**Dover Municipal Landfill Superfund Site
Second Consent Decree for RD/RA**

2004 Amended ROD

**AMENDED RECORD OF DECISION
DOVER MUNICIPAL LANDFILL
DOVER, NEW HAMPSHIRE**

September 30, 2004

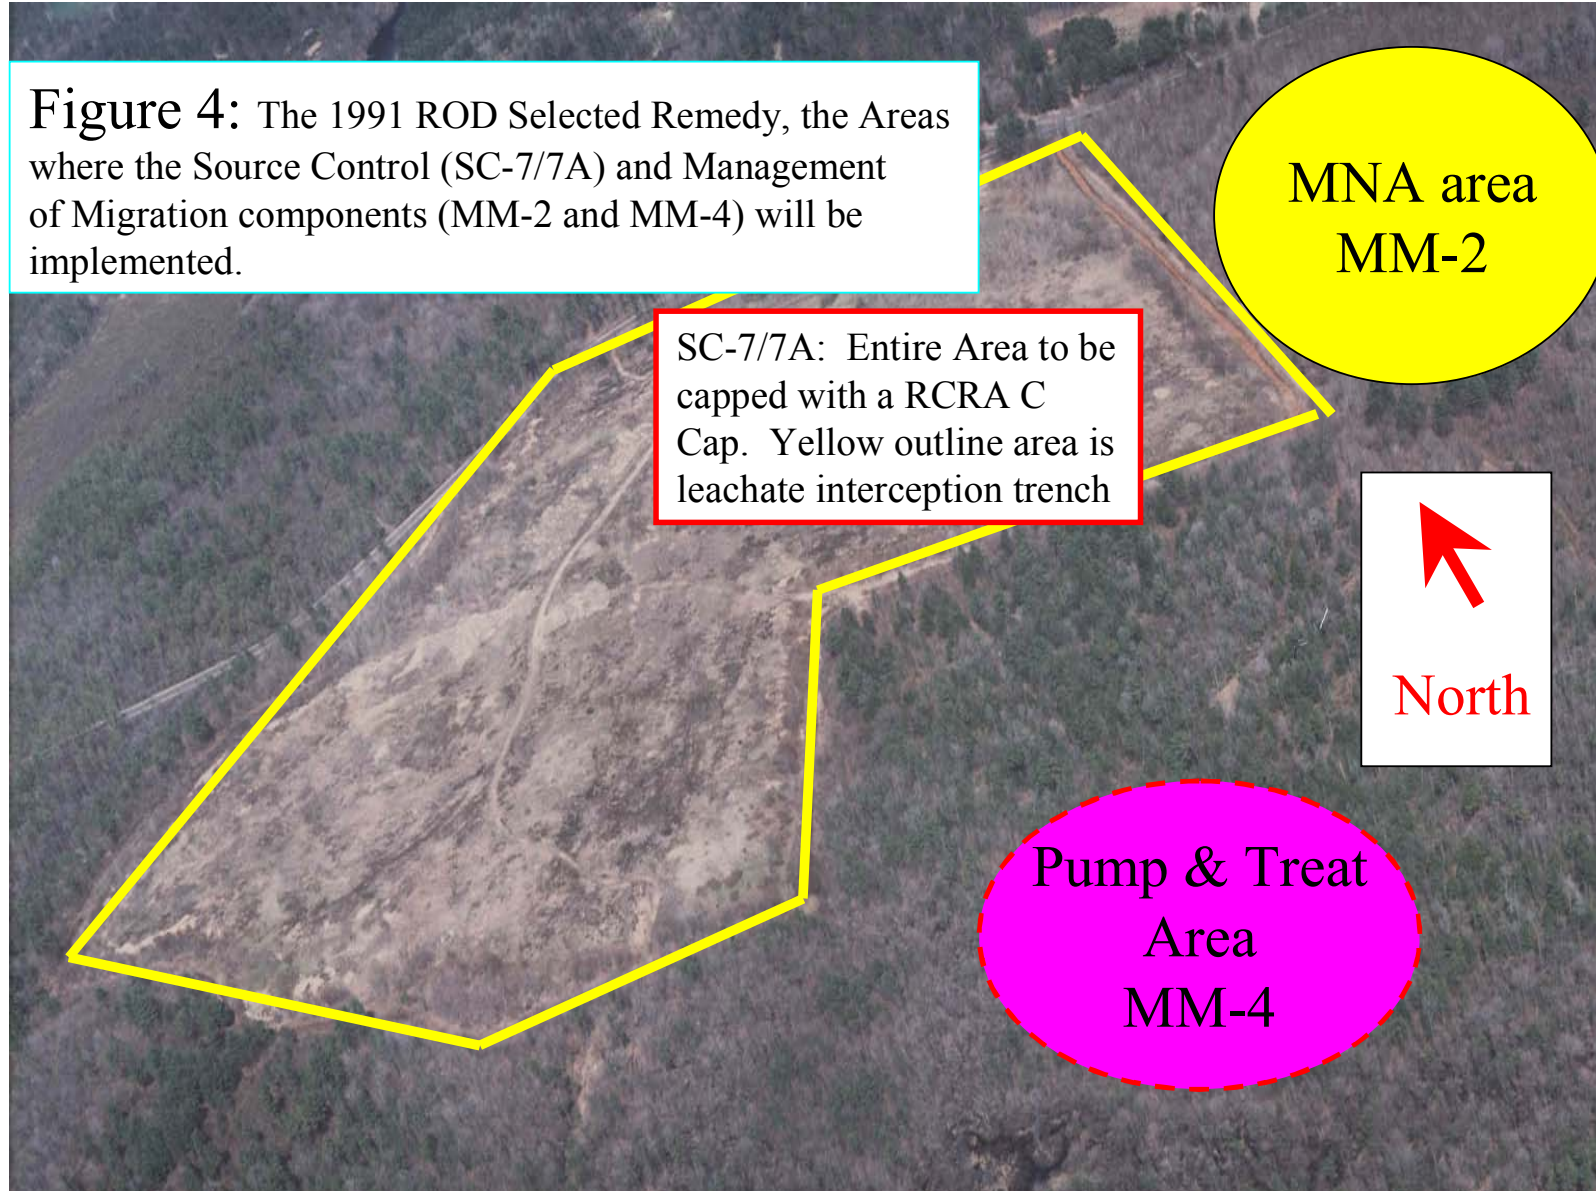
Figure 4 on the following page shows the 1991 ROD Remedy schematically. The area of capping and the ground water remediation areas are generally marked. Figures 11 and 12 of the 1991 ROD show the general construction of the cap and interceptor/diversion trench.

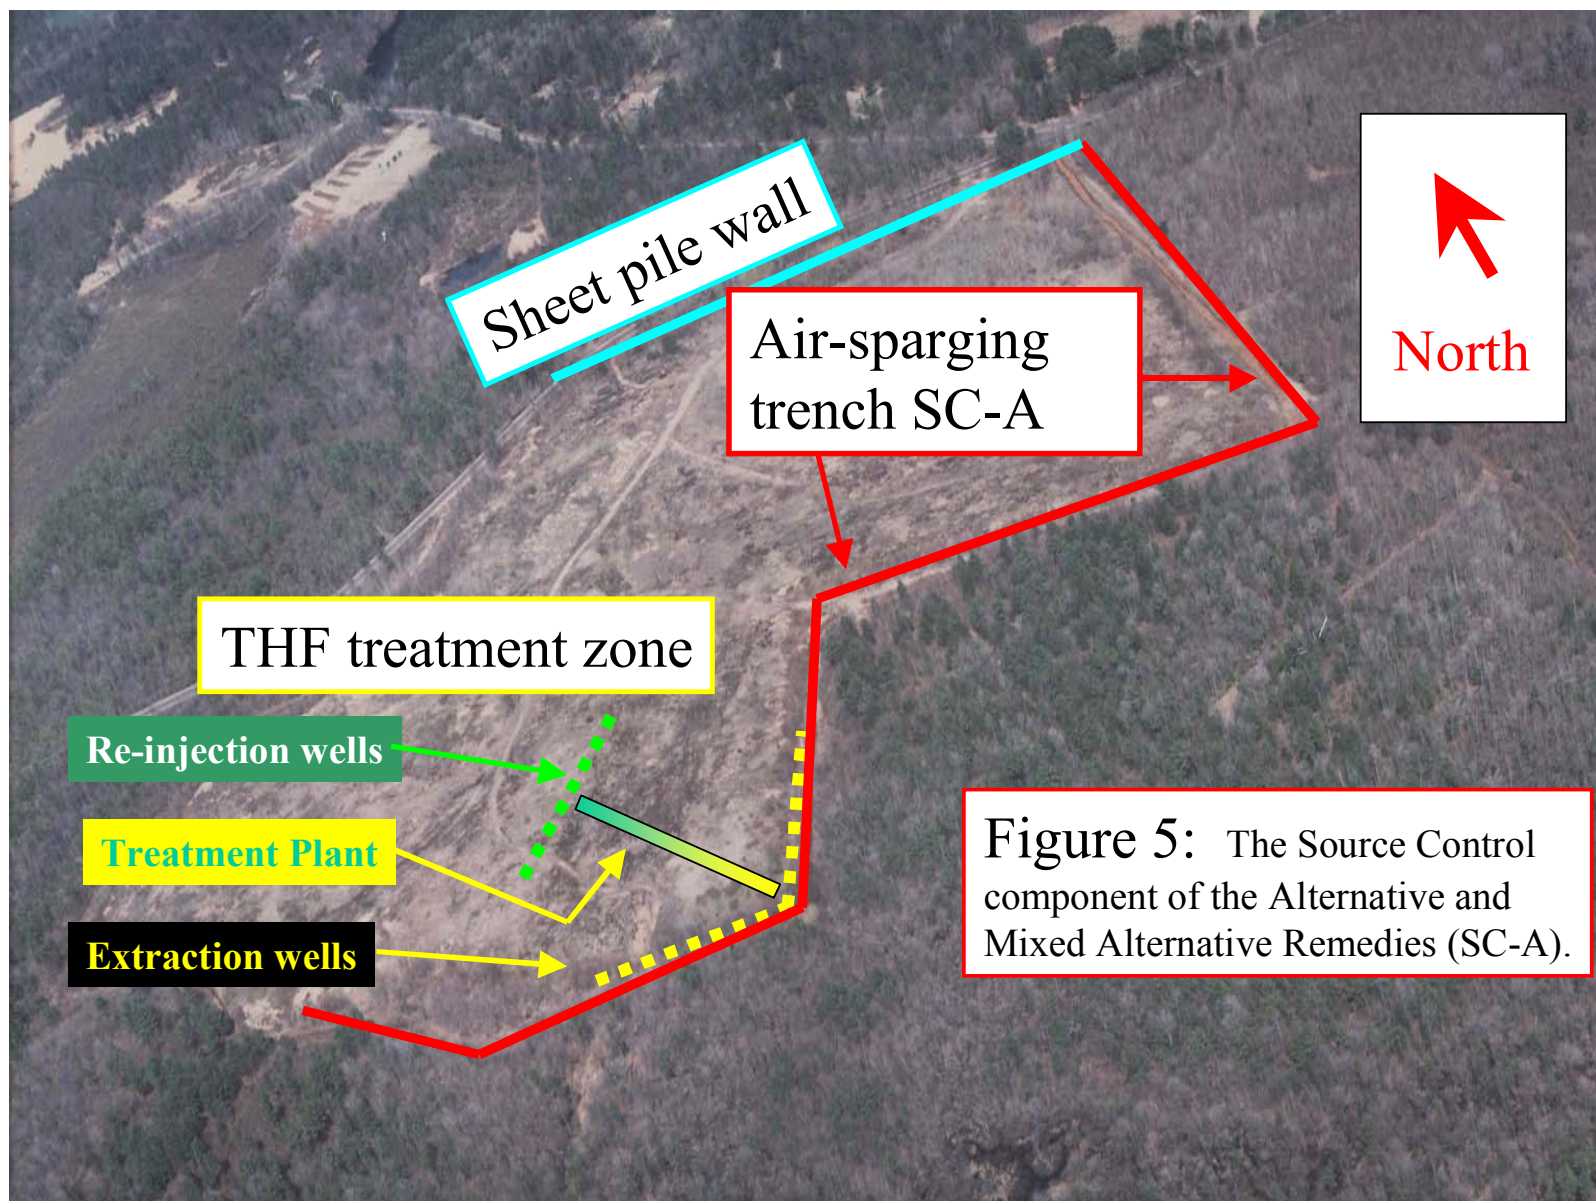
Figure 5, on page 48, depicts a schematic layout of the alternative Source Control component of

the Alternative and Mixed Alternative. A schematic representation of the air-sparging trench is offered in Figure 6, which directly follows Figure 5.

Following the path shown on Figure 5 on page 48, the volume of soil excavation, assuming a three-foot wide treatment zone that spans the upper sand and upper-interbedded aquifers, is approximately 19,000 cubic yards. The air-sparging trench will intercept, capture or destroy contaminants in leachate emanating from the landfill. Although this is similar in nature to the interceptor/diversion trench described on page 54 of the 1991 ROD, its construction, operation, and goals are very different. The air-sparging trench will not serve to extract water for *ex situ* treatment as in the 1991 ROD. Instead, water will be treated in the air-sparging trench to immobilize arsenic, capture VOCs in the air stream and extract them, and to aerobically degrade THF. Air emitted from the air-sparging trench is not expected to require treatment; however, the stacks may be retro-fitted with treatment devices if necessary.³⁴ For cost purposes, it is estimated that this air-sparging trench will operate for at least 30 years; however, the air-sparging trench must remain operating until the landfill has reached clean closure. There are a number of sub-components to this portion of the remedy:

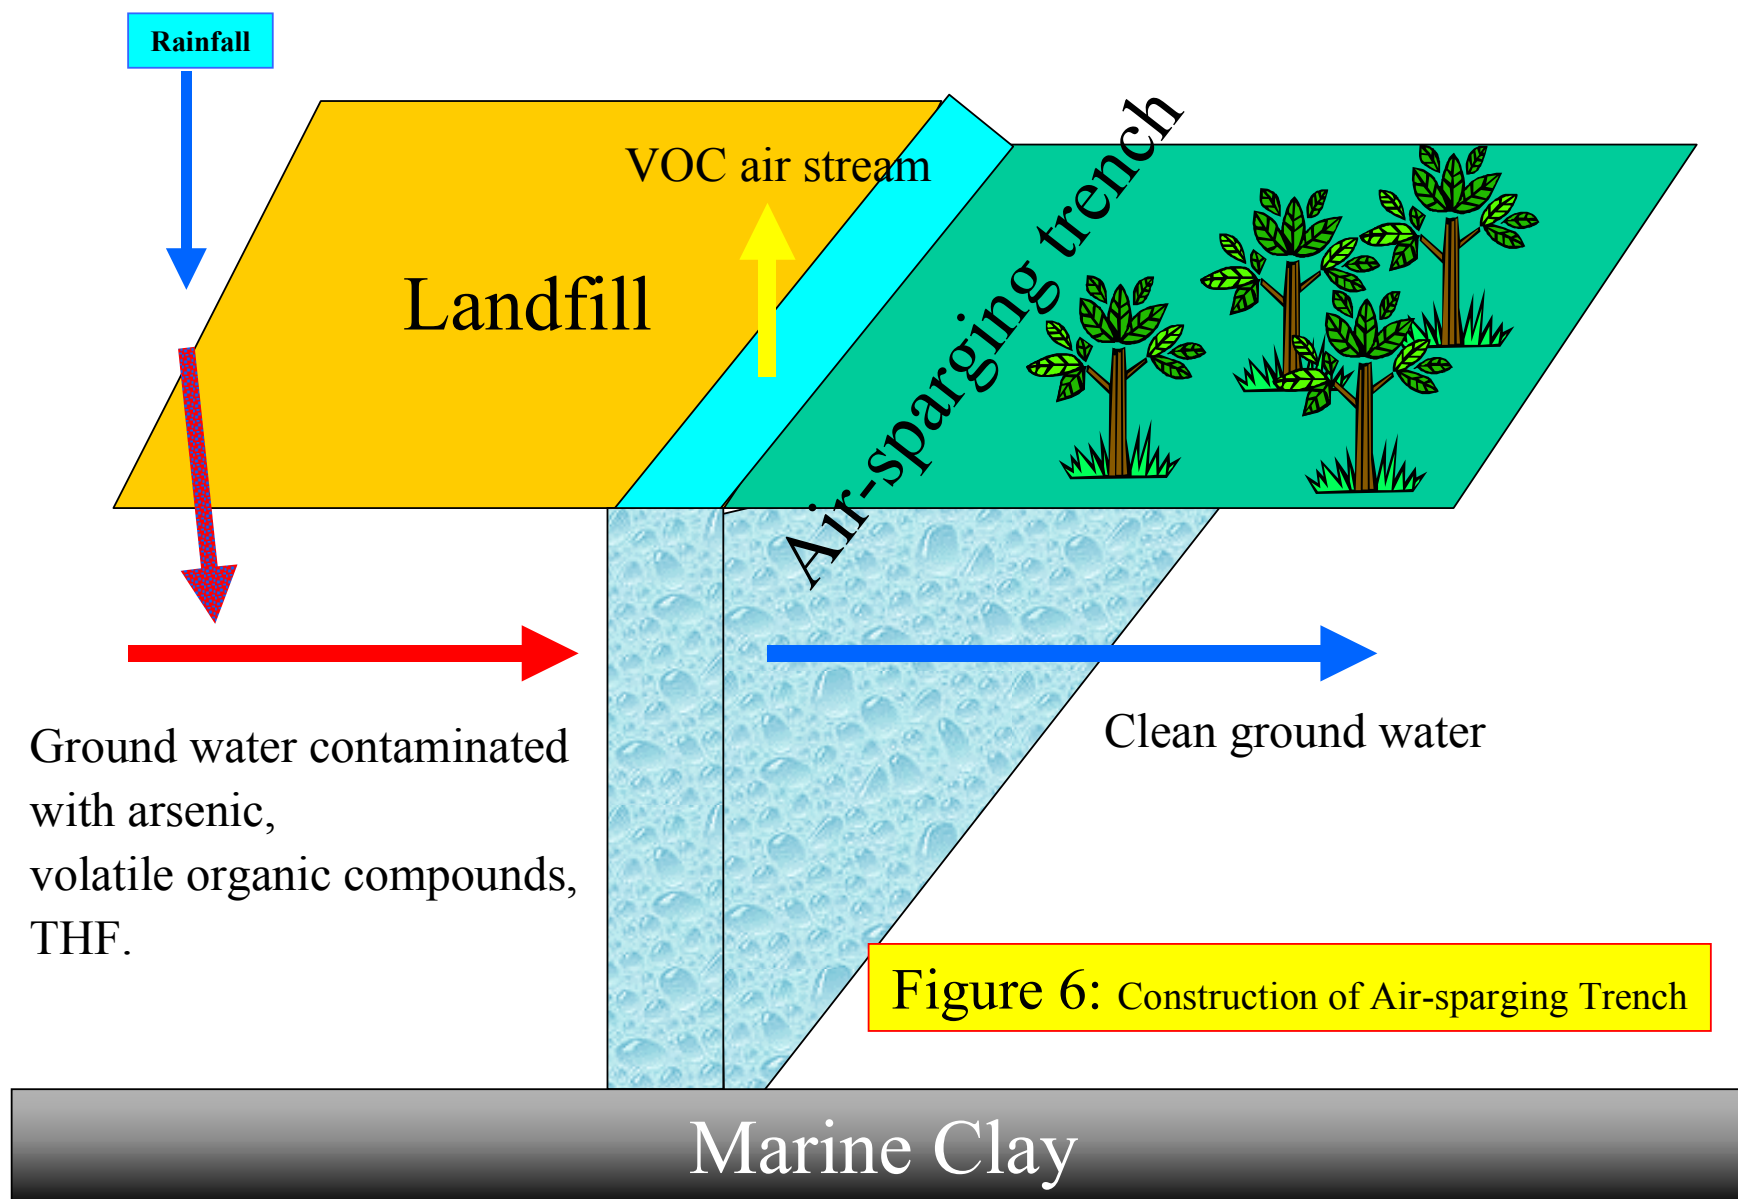
See Section K. 4., *Expected Outcomes* for further discussion regarding the air-sparging trench contingency in the event of failure. A schematic representation of the air-sparging trench is offered in Figure 6 on page 49.
